City of Portland, Maine - Building or Use Permit Application

Permit No: 02-1309	Issue Date: MAY 27 2003	BL: 153 A025001
-----------------------	----------------------------	--------------------

Job Name: Radcliffe Glen

Re: Radcliffe Glen

7516.1 9/16/02 FIGURE 1

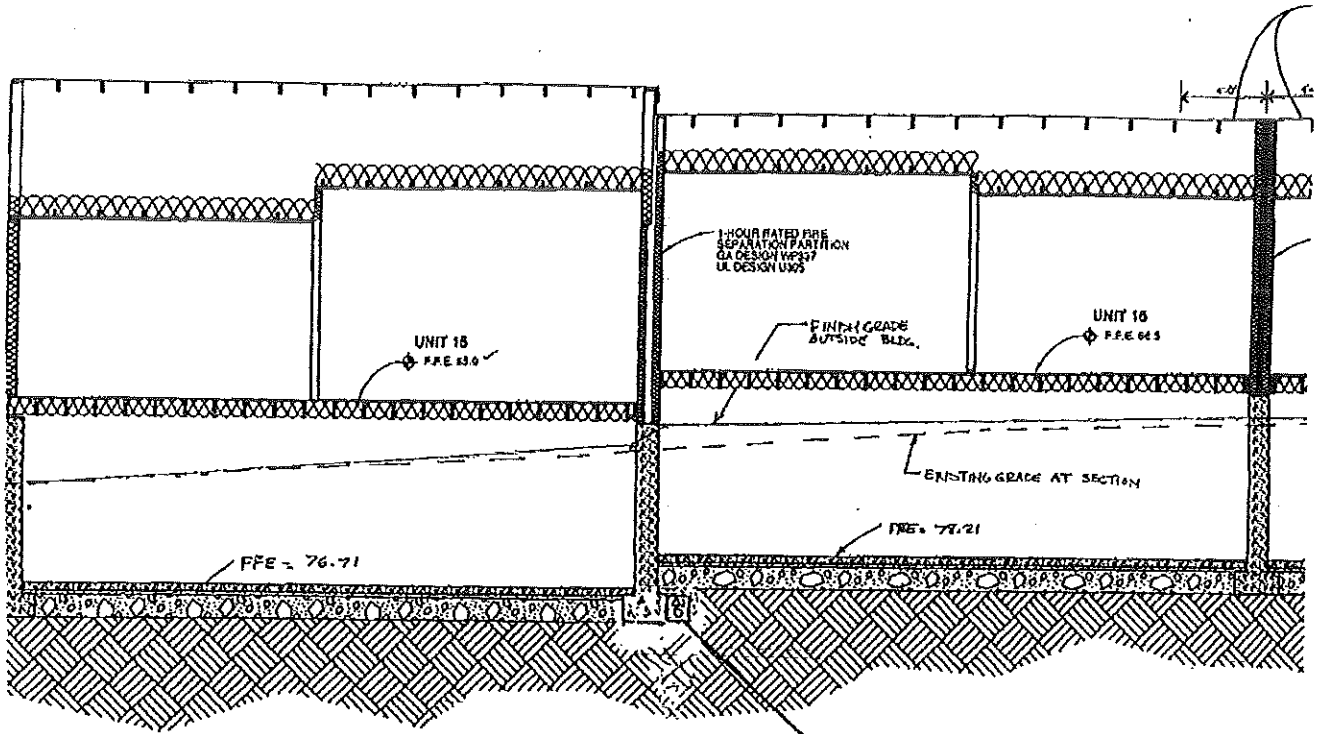
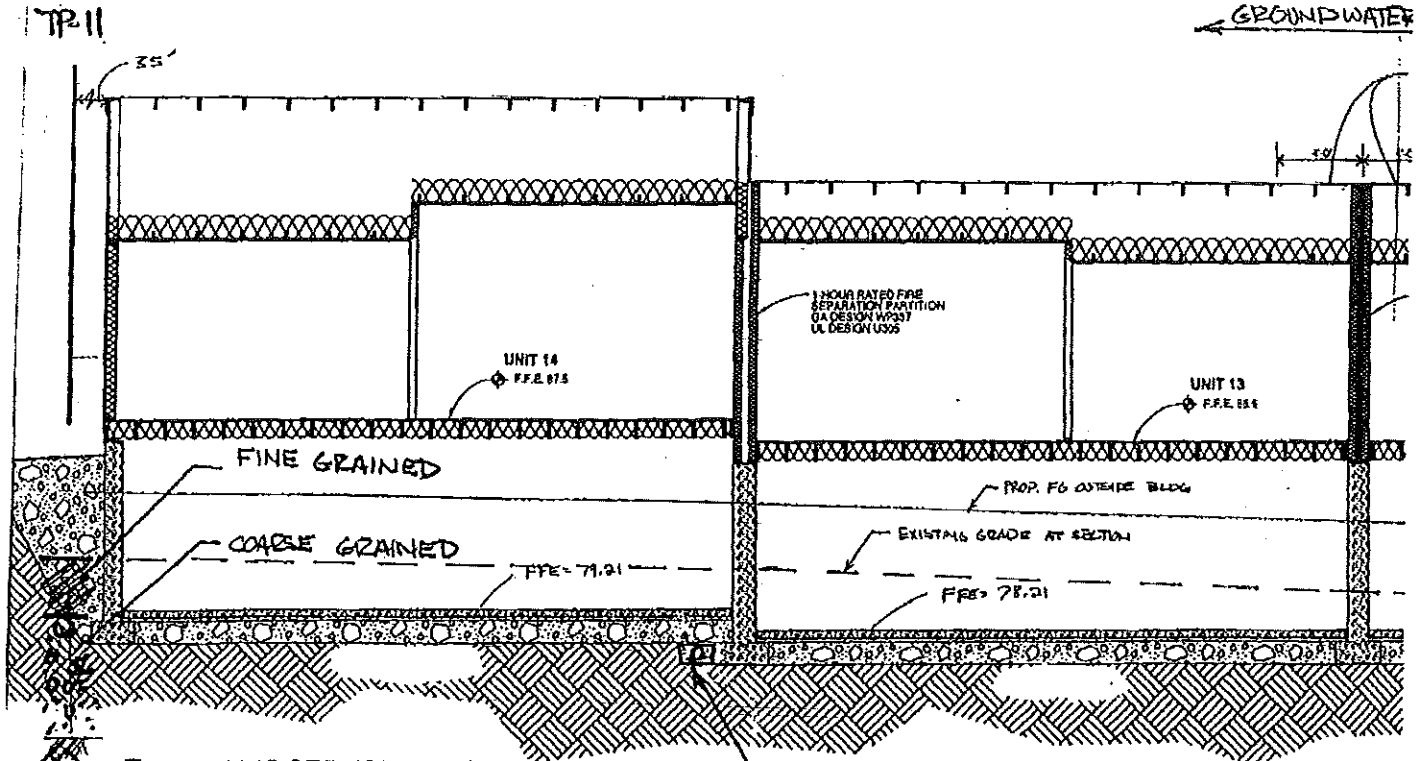
Based on subsurface conditions encountered at test pit TP-10, which was excavated within the footprint of the Units 11-14 building, and TP-12, which was excavated within the footprint of the Units 15-18 building, and the proposed finish floor elevations of the units, we recommend that foundation drains be placed at the bottom of footings where the basement slabs-on-grade step down in elevation in addition to the perimeter foundation drains recommended in our geotechnical report dated June 14, 2002. The proposed internal foundation drain locations are illustrated on Figure 1.

The internal wall footings at Units 11-14 could be located in coarse-grained glacial marine stratum overlying bedrock based on the proposed elevations and profile illustrated on Section A304. At the time of the exploration, groundwater levels were below the projected bottom of footings. Depending on the prevailing hydrogeologic conditions, the bottom of the footings could be located in groundwater during wetter periods of the year. Internal foundation drains will provide drainage relief for migrating groundwater and prevent buildup of groundwater behind the internal footings.

Based on soil conditions encountered at TP-12 and proposed slab elevations, bedrock excavation will likely be required to construct the basement slabs and footings. Removal of rock for footing trenches could create low areas in the rock that will collect groundwater. In addition, fracturing of bedrock could provide pathways for groundwater to flow below upgradient footing drains. Therefore, internal footing drains are recommended at steps in elevation of the partition wall footings.

Underdrains should consist of 4 inch rigid perforated PVC surrounded by a minimum of 6 inches crushed stone wrapped in filter fabric to prevent clogging from the migration of the fine soil particles from the native soils and Foundation Backfill. The crushed stone should be placed up to the bottom of the Structural Fill. The footing underdrains should be graded to provided positive drainage to a free-flowing outlet. Depending on the grading of the perimeter foundation drains, it may be possible to connect the internal foundation drains to the perimeter foundation drain system. The ends of the underdrain pipes exposed to the atmosphere should be covered with screening or other device to prevent nesting of wildlife.

It is our understanding perimeter foundation wall profile could allow for the internal foundation drain outlet pipe to be routed around steps in the perimeter foundation. Where the internal foundation drain outlet pipe will pass below a footing, we recommend that the outlet pipe be carried beneath the footing in a ductile steel pipe casing or encased in reinforced concrete to protect the drain pipe from concentrated foundation loads. The steel casing should only be larger enough to pass the drain pipe through the casing.

Weep tubes through foundation walls are not necessary provided that internal foundation drains are used as recommended above. Please do not hesitate to contact me if you have any questions.
